IN THE DRAWINGS

REMARKS

0
Annotated Marked-up Drawings

Figure 11

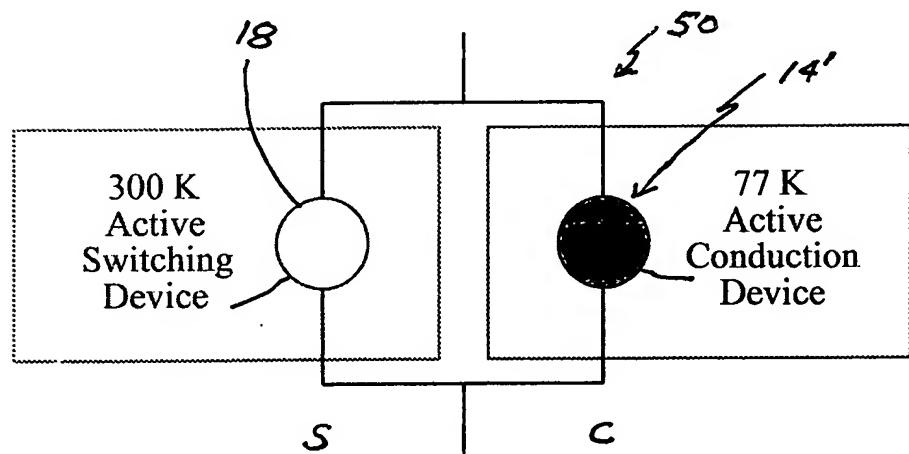
Figure 11 is herein amended with a replacement sheet by addition of reference numeral 50 to identify the hybrid switch.

Figures 2 and 11 have been corrected and replacement sheets have been provided including those figures on respective sheets. Marked-up copies of the figures are also provided to show the modifications. Please note that reference numeral 50 is used in amended Figure 11 because numeral 40 was already designated in Fig. 2 for the control function.

Figure 2

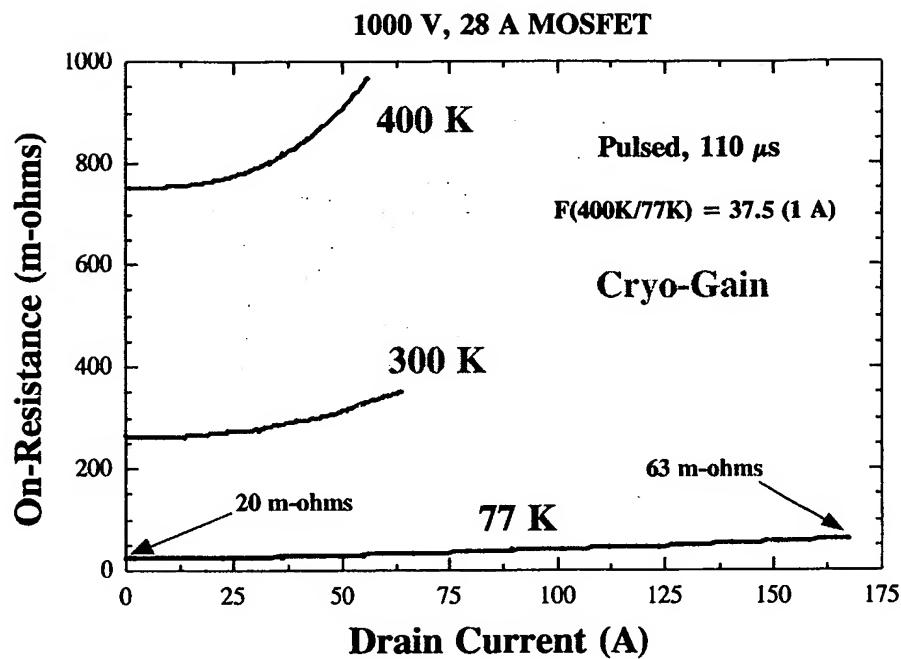
Figure 2 is herein amended with a replacement sheet by addition of reference numeral 16 to identify diodes.
